PLANNING DIVISION REPORT AND RECOMMENDATION TO THE DIRECTOR

Project: Type II Site Plan Review and Type I Design Review – Barksdale Station – Taco Bell
File Number: PLNG2019-033 and PLNG2020-003
Date of Report: May 7, 2020
From: Lisa Klein, AHBL (Planning Consultant to the City)

SUMMARY OF REQUEST: City approval is required for Type II Site Plan Review (PLNG2019-033) and Type I Design Review (PLNG2020-003) for the new Barksdale Station Taco Bell.

SHEET NO.
C1.1

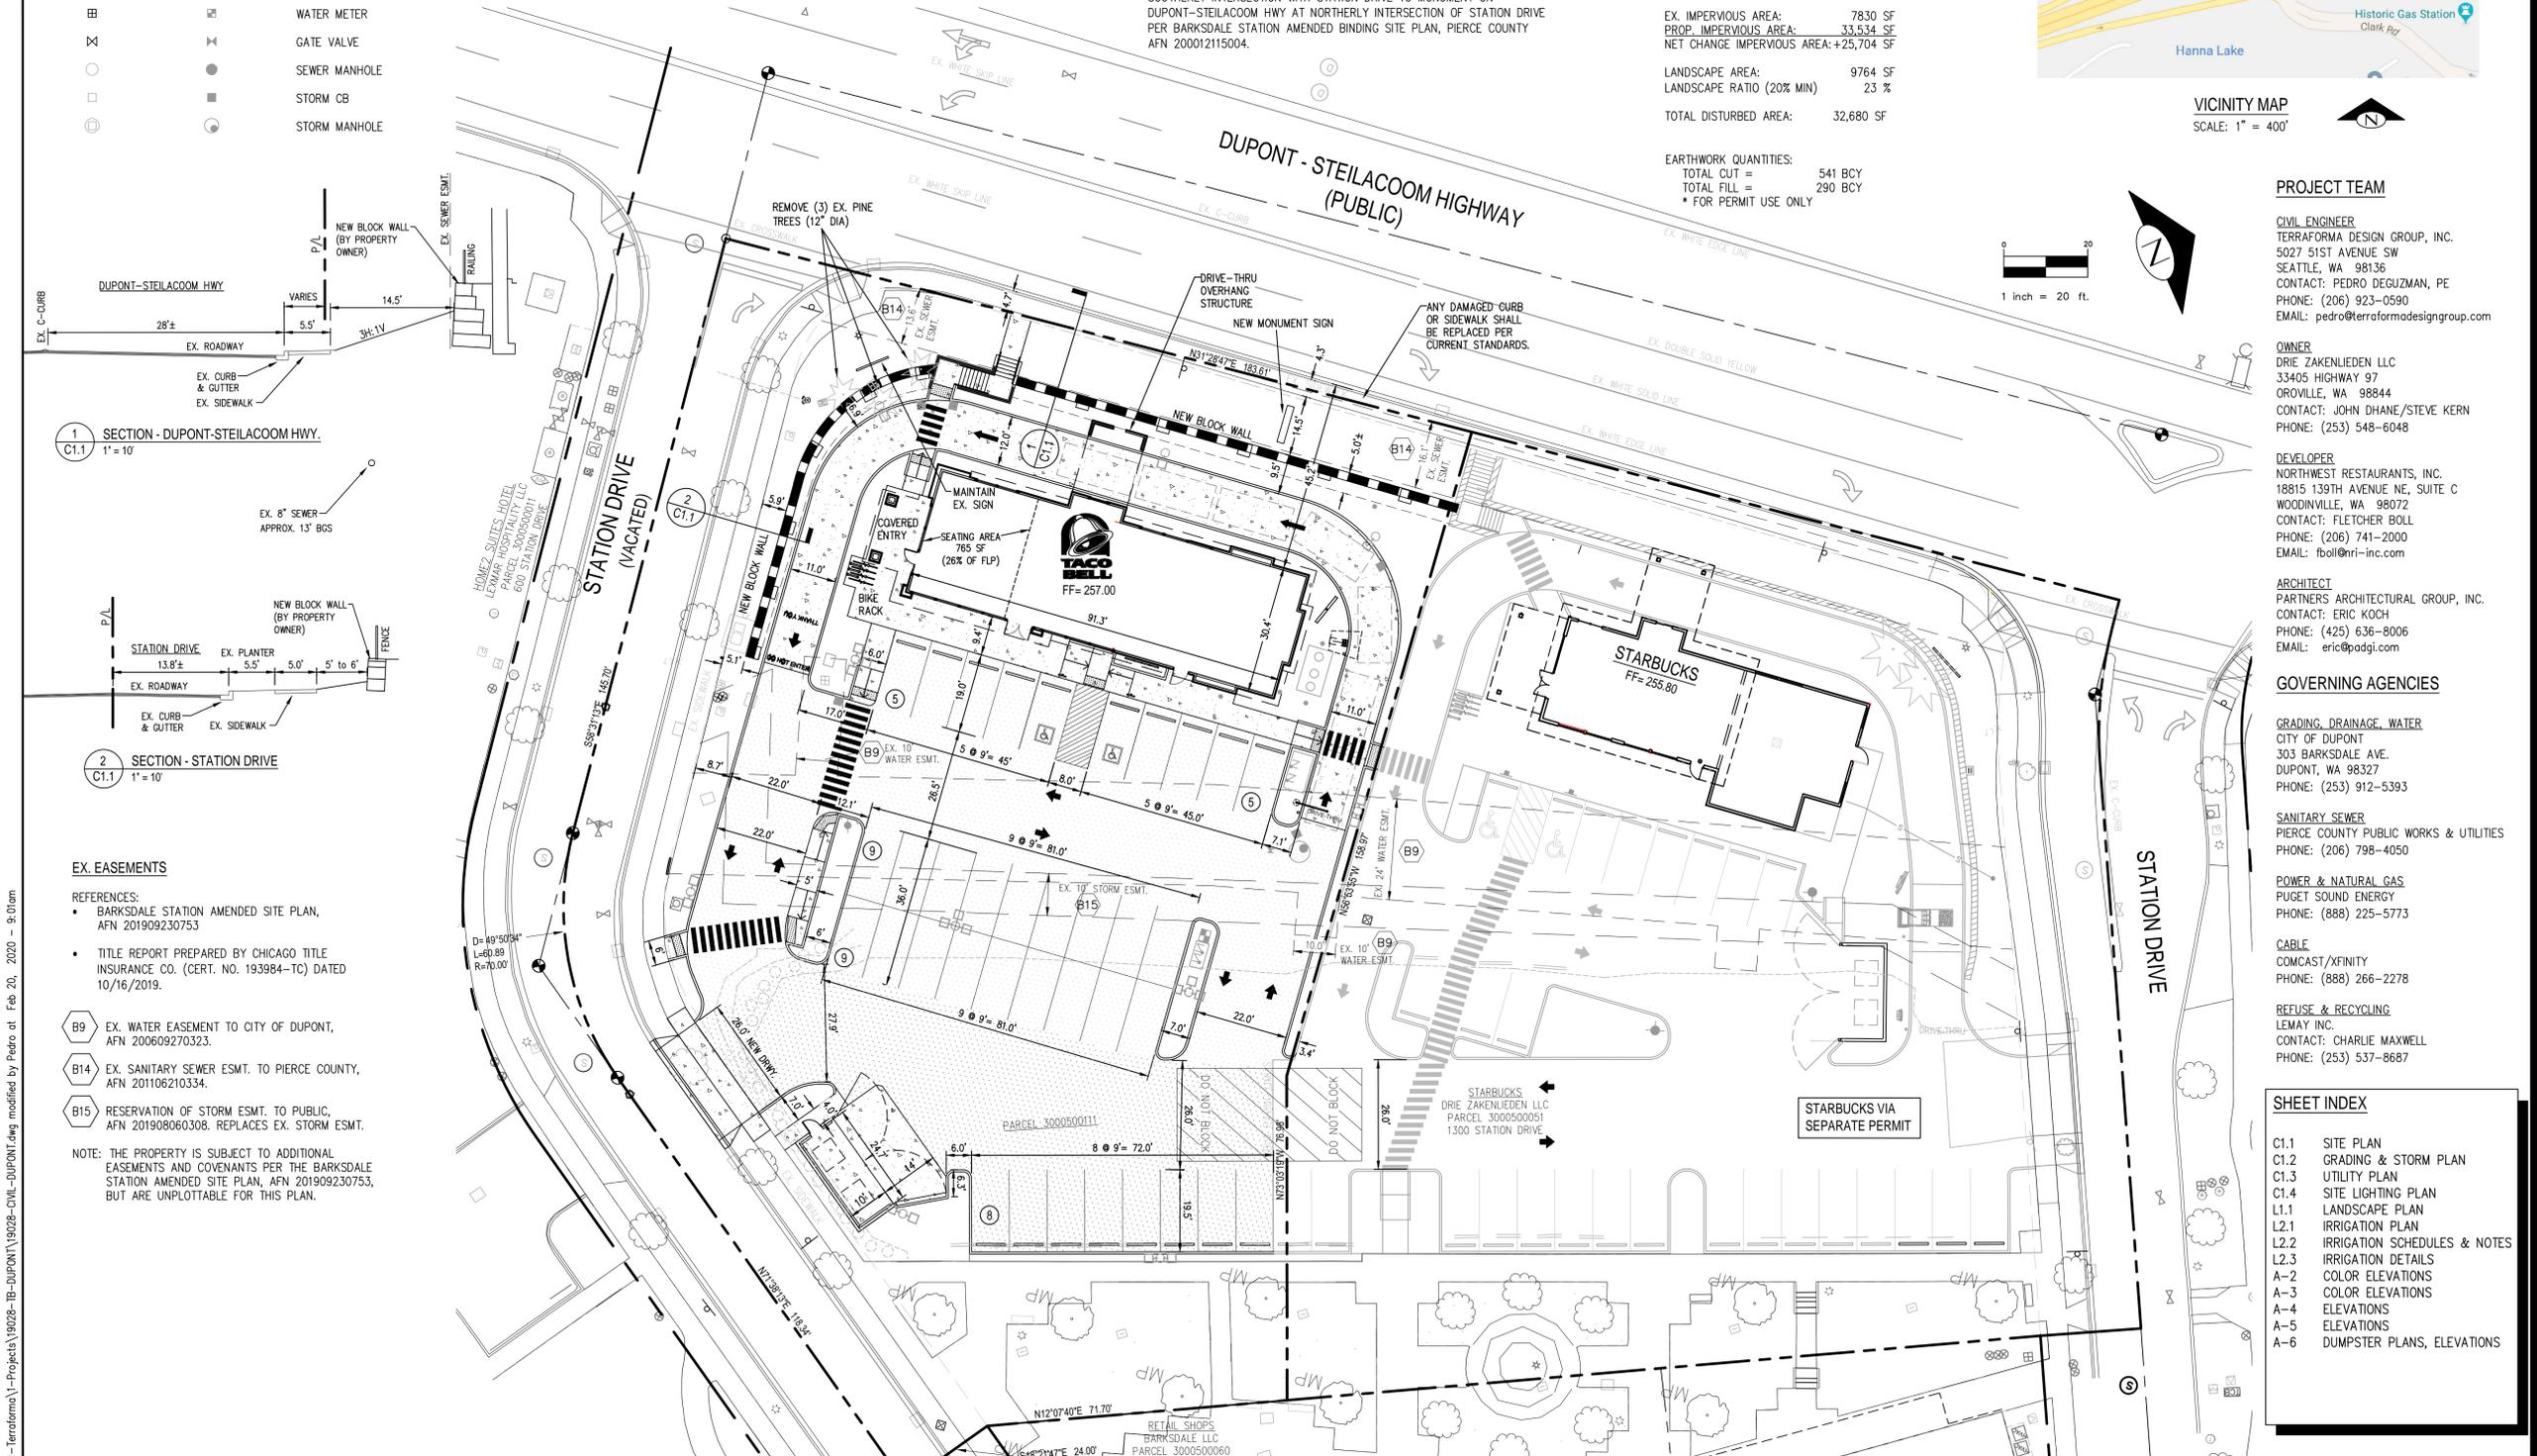
Staff Analysis and Conclusion: The proposed restaurant use with drive-thru is a permitted use as long as 15 percent of the restaurant total floor area is provided as indoor seating. Per the Site Plan (Sheet C1.1), the applicant is proposing a 26 percent (765 square feet) seating area within the 2,900 square foot building. The proposal is compliant.

Staff Analysis and Conclusion: The site plan sheet C1.1 states that 9,764 square feet (23 percent) of the 43,298 square feet parcel will be landscaped. The proposal is compliant.

Staff Analysis and Conclusion: The Site Plan on Sheet C1.1 identifies a new monument sign. The applicant has not submitted a sign permit application with the land use application. A sign permit is required for any building or other monument signage in accordance with the requirements of DMC 25.116. The analyses and recommendations in this Staff Report do not include an analysis of the conformity of proposed signage with the City's Sign Code. A future sign permit application will evaluate the signage for compliance with DMC 25.116. (Condition 2)

Staff Analysis and Conclusion: The Site Plan (Sheet C1.1) depicts parking rows all with less than 12 stalls. Six-foot wide planters are provided at the end of all parking aisles. All parking areas provide a five-foot pedestrian connection from the parking area to the building area. Concrete curb surrounds the parking lots but it is not known if they are six inches tall. The proposal appears to provide raised sidewalk adjacent to the proposed public works building but it is not clear if these areas are raised six inches above the parking lot. The Site Lighting Plan (Sheet C1.4) depicts outdoor and parking area lighting mounting height between 10 and 15 feet that provide pedestrian scaled lighting.

SHEET NO.
C1.4

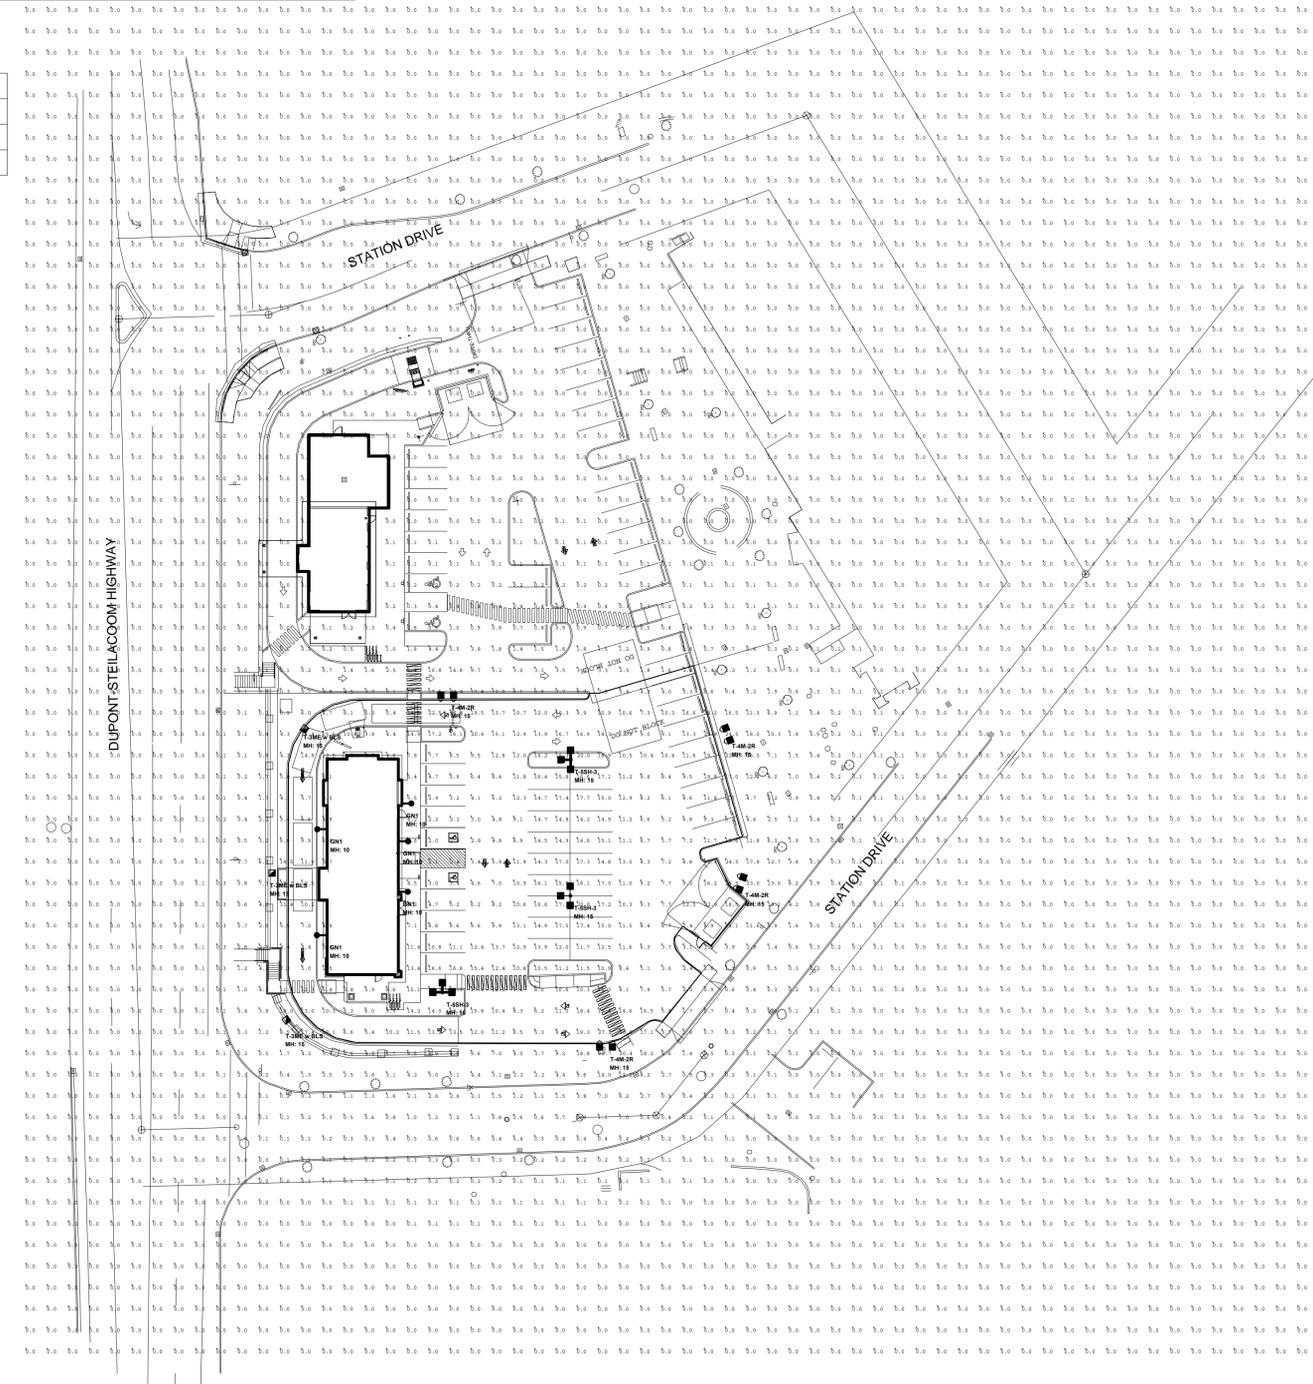
Staff Analysis and Conclusion: The Site Lighting Plan (Sheet C1.4) provides limited lighting details. The light levels average more than one foot-candle along all public areas. This site plan notes that the maximum heights of the building mounted lights at 10 feet and the parking area lighting at 15 feet. The submittal did not include all lighting details and fixture type cut sheets. A proposed lighting plan that indicates all light fixture type and lumens shall be provided at the time of site development permit demonstrating compliance with DMC 25.70.070(12). (Condition 8.a)

9. The proposal needs to show compliance with DMC 25.70.070(12). Provide a photometric plan and height of site lighting that is in compliance with City standards. **See new Site Lighting Plan – Sheet C1.4.**

SHEET TITLE
LANDSCAPE PLAN
SHEET NO.
L1.1

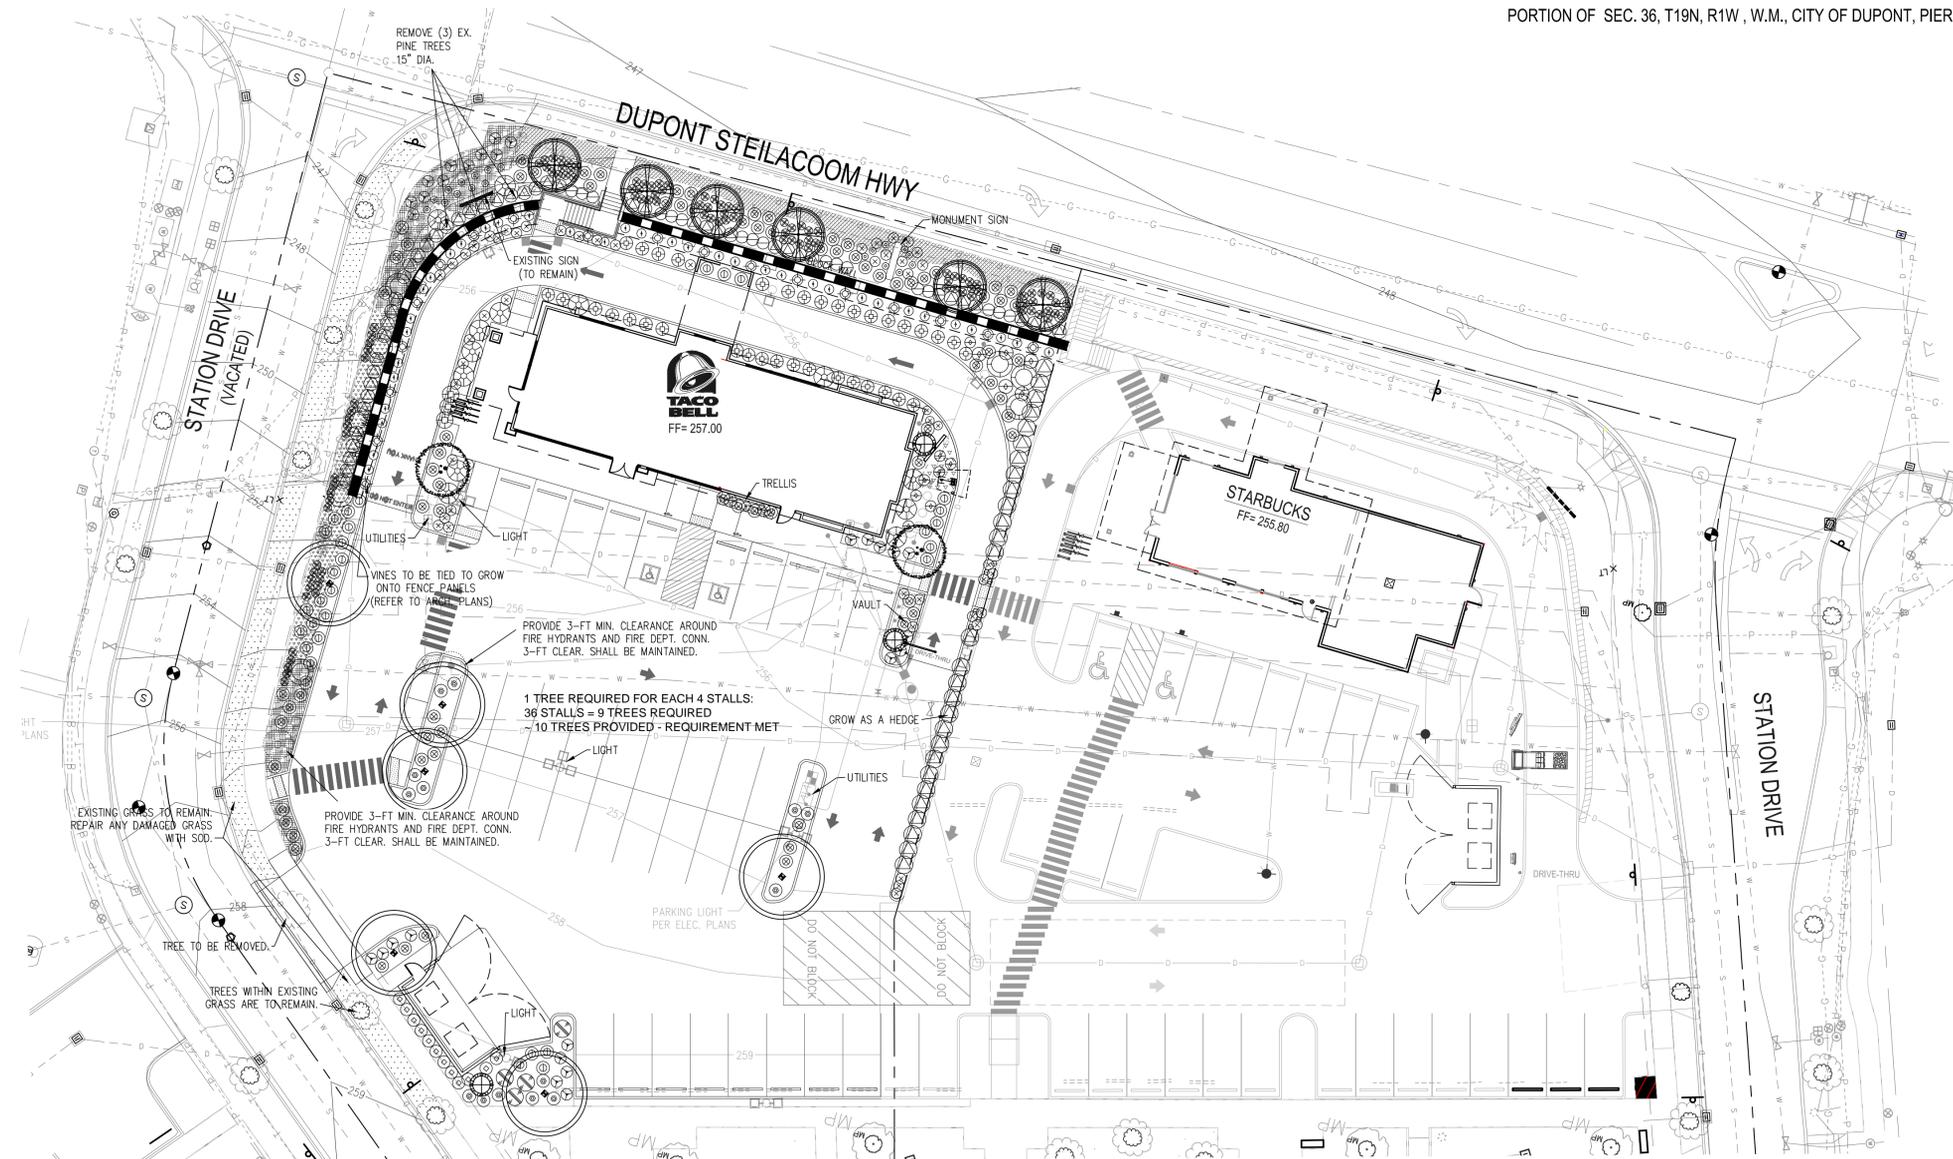
Staff Analysis and Conclusion: The Taco Bell parcel is approximately 0.99-acre, which requires the retention of three trees. The Landscape Plan (Sheet L1.1) indicated that eight trees will be retained.

Per DMC 25.70.030(2)(e) and (3)(g), an average of one tree per four parking stalls shall be provided. The project proposes 36 parking stalls that will require nine trees in the parking lot area. The Landscape Plan (Sheet L1.1) indicates that the proposal will plant nine trees and is compliant.

Per the proposed landscape plan (Sheet L1.1), street trees are spaced between 17 and 39.5 feet along DuPont-Steilacoom Road; the largest spacing appears to be accommodating a proposed monument sign (that has not been permitted). While the average spacing is 20-feet between each street tree, DMC 25.90.030(a) states that “street trees shall be between 25 and 30 feet”. There are no code provisions for averaging the spacing. Tree grates are not provided or required as the trees are not located in pavement areas.

1 WEST ELEVATION
A-4 SCALE 1/4"=1'-0"

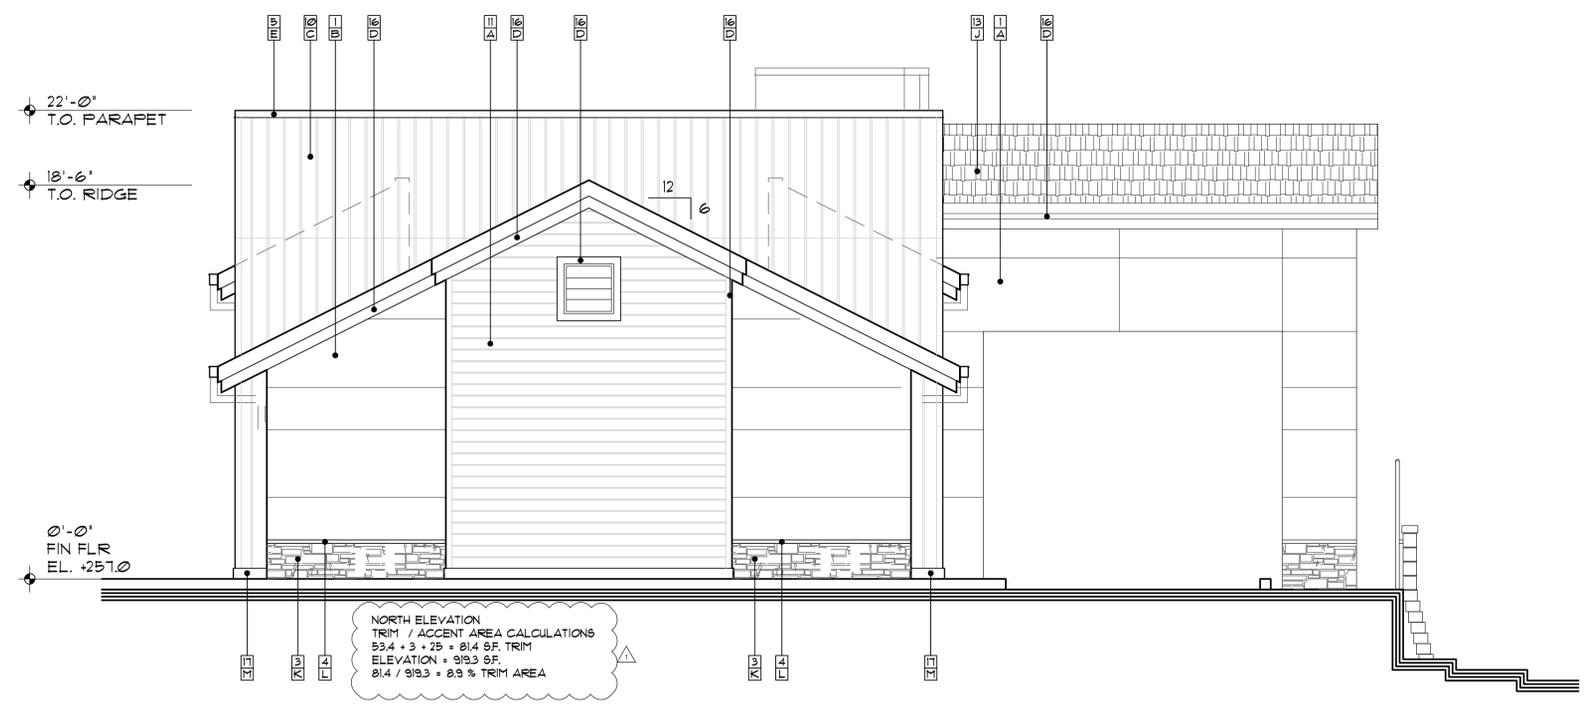
The proposed commercial building includes a blank wall segment that exceeds 15-feet in width and is between two and eight feet in height. The West Elevation (Sheet A-4) has a blank wall on the portion of the west elevation between the canopy and south facade and between the top of the windows and bottom of the roof line. The west facade includes a number of trees and shrubs to be planted adjacent to the building together with groundcover but the landscaping in the described area is a bamboo shrub that will not mature to a height that will adequately cover the blank wall area. One additional window added adjacent to the north of the two existing windows in this area would meet the City's blank wall requirements and provide balance for the west elevation. (Condition 14)
